Amendments to the Drawings:

### REMARKS

FIG. 7

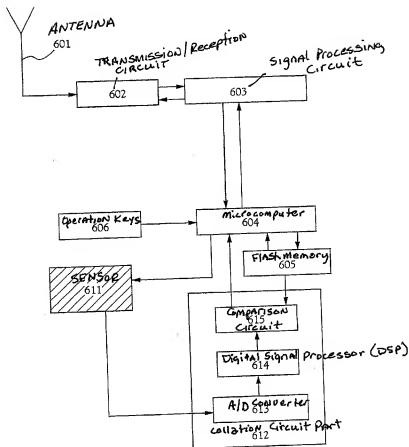
The attached replacement sheets of drawings include changes to Figs. 7, 8 and 12 and replace the original sheets including Figs. 7, 8 and 12.

In Figs. 7, 8 and 12, labels have been added to the corresponding numbers in order to better identify each element.
